Addendum Number: 03

Addendum Issue Date: April 28, 2025

Project Name: Robinson Washington Elementary
Renovation & Addition

Project Number: 02401781.001

SHEET TITLE:
**ENLARGED
MECHANICAL PIPING
FLOOR PLAN - AREA
C**

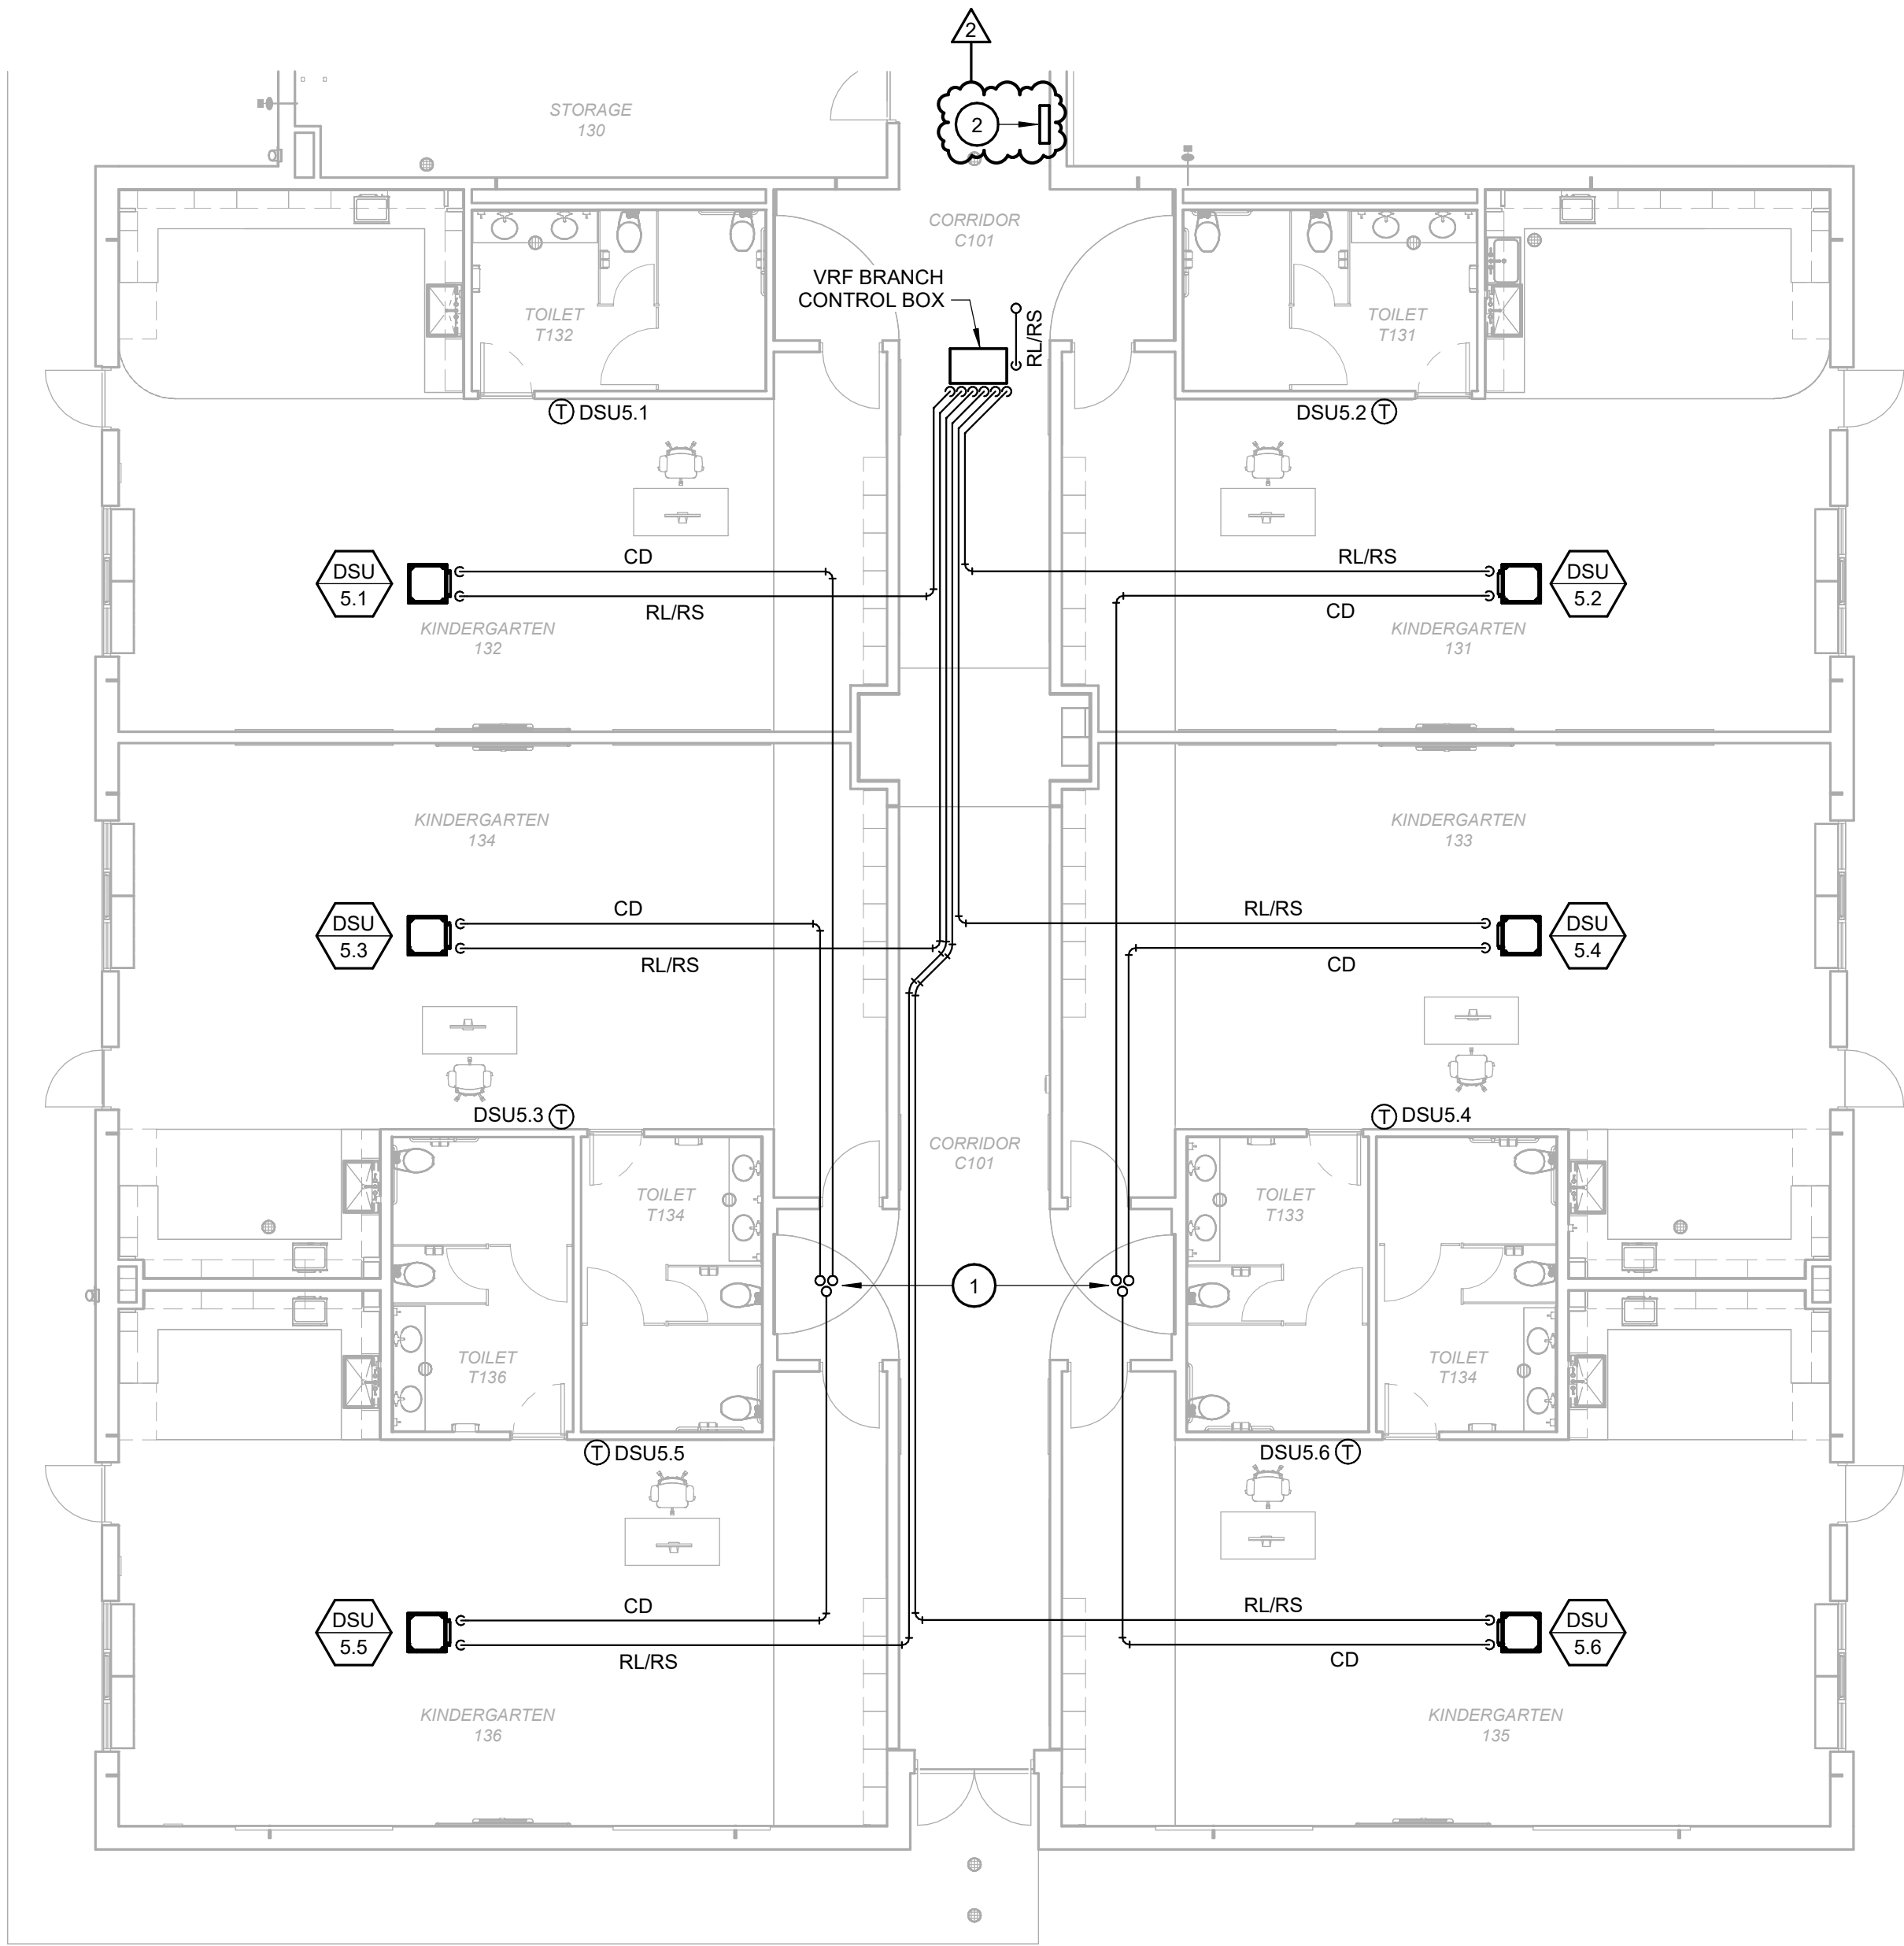
- b. ADD keynotes #2 and #3.
12. M2.1C – ENLARGED MECHANICAL PIPING FLOOR PLAN – AREA C
 - a. ADD VRF System control panel locations.
 - b. ADD keynote #2.

- 1 CONDENSATE DRAIN PIPING ROUTED UP THROUGH ROOF. SEE SHEET M1.4 FOR CONTINUATION.
- 2 VRF SYSTEM LOCAL CONTROL PANEL SHALL BE INSTALLED IN CORRIDOR NEAR VRF BRANCH CONTROL BOX. PROVIDE ALL NECESSARY LOW VOLTAGE WIRING TO VRF DUCTLESS UNITS, BRANCH CONTROL BOX, HEAT PUMPS AND MAIN BAS/VRF CONTROL PANEL.

ENLARGED MECHANICAL PIPING FLOOR PLAN - AREA D

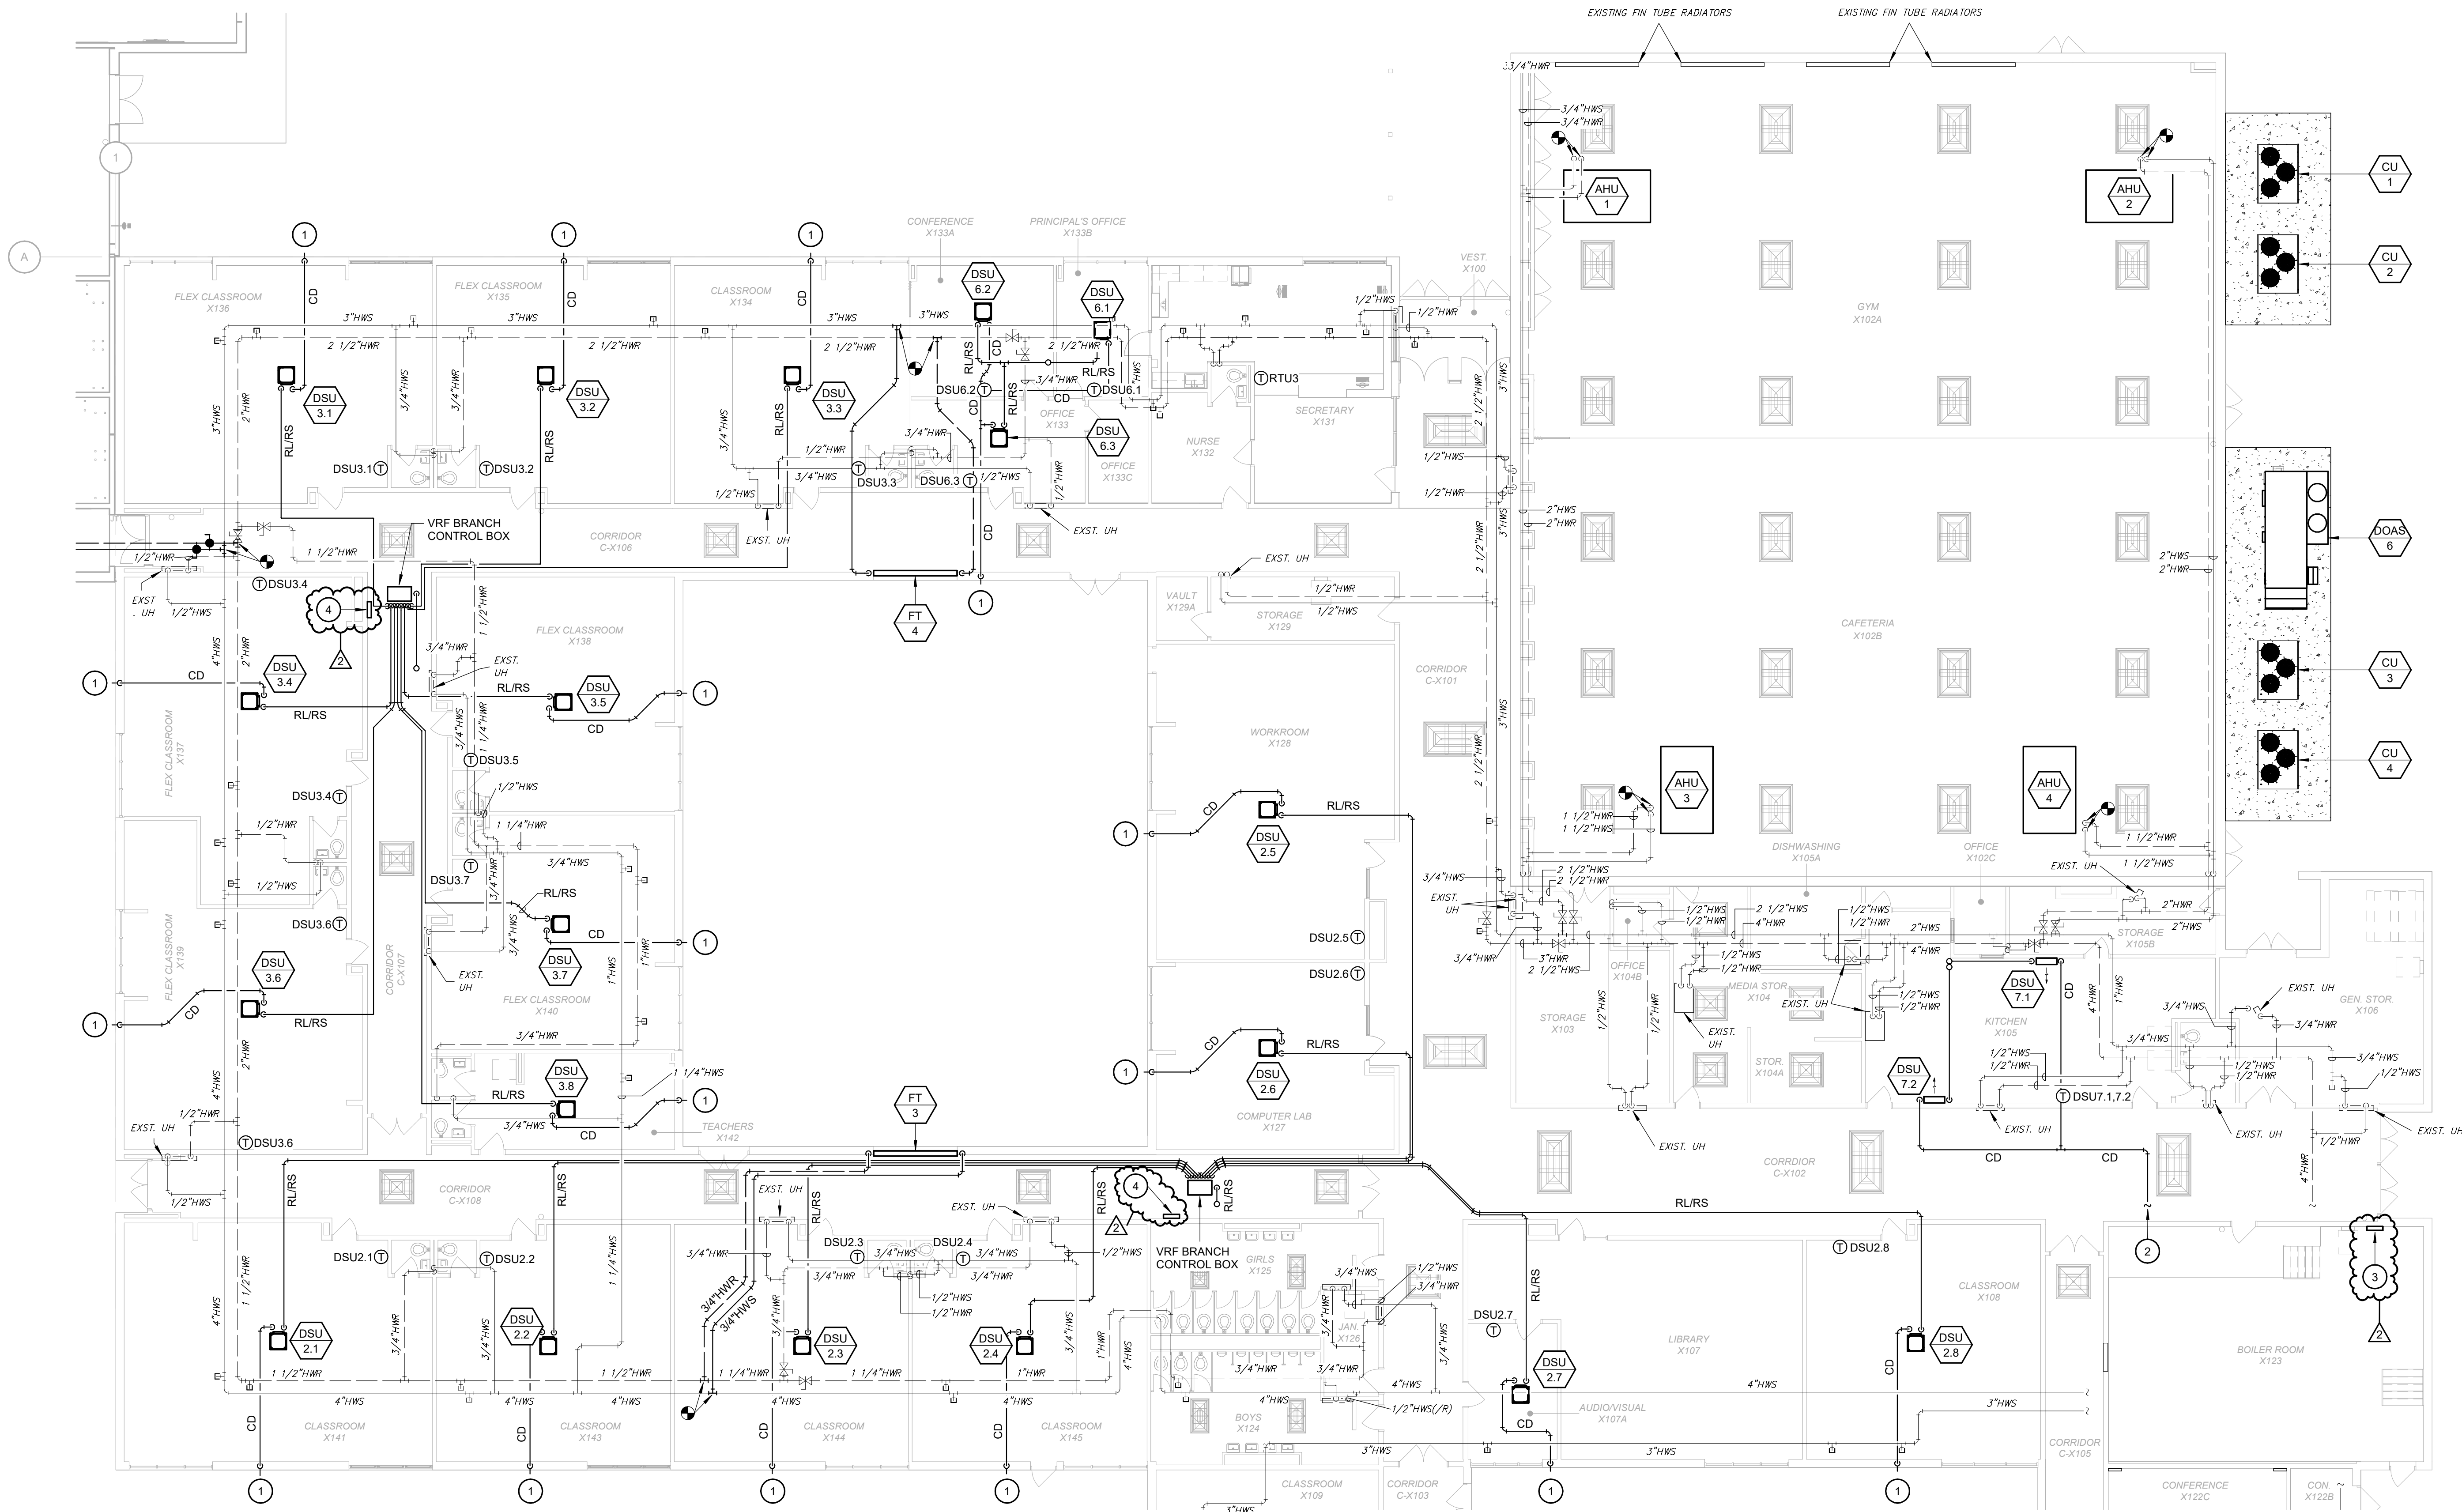
13. M2.1D – ENLARGED MECHANICAL PIPING FLOOR PLAN – AREA D
 - a. ADD VRF System and hot water plant control panel locations.
 - b. ADD keynotes #3 and #4.

- ROUTE CONDENSATE DRAIN DOWN THROUGH EXTERIOR WALL AND DRAIN WITHIN 2 FT OF GRADE LEVEL.
- ROUTE CONDENSATE DRAIN PIPING FROM DSU7.1 AND 7.2 TO NEAREST CONVENIENT FLOOR DRAIN WITHIN BOILER ROOM X123.
- HOT WATER PLANT CONTROLLER SHALL BE INSTALLED IN BOILER ROOM X123 IN MOST CONVENIENT LOCATION. PROVIDE ALL NECESSARY LOW VOLTAGE WIRING TO HOT WATER BOILER AND PUMPS.
- VRF SYSTEM LOCAL CONTROL PANEL SHALL BE INSTALLED IN CORRIDOR NEAR VRF BRANCH CONTROL BOX. PROVIDE ALL NECESSARY LOW VOLTAGE WIRING TO VRF DUCTLESS UNITS, BRANCH CONTROL BOX, HEAT PUMPS AND MAIN BAS/VRF CONTROL PANEL.
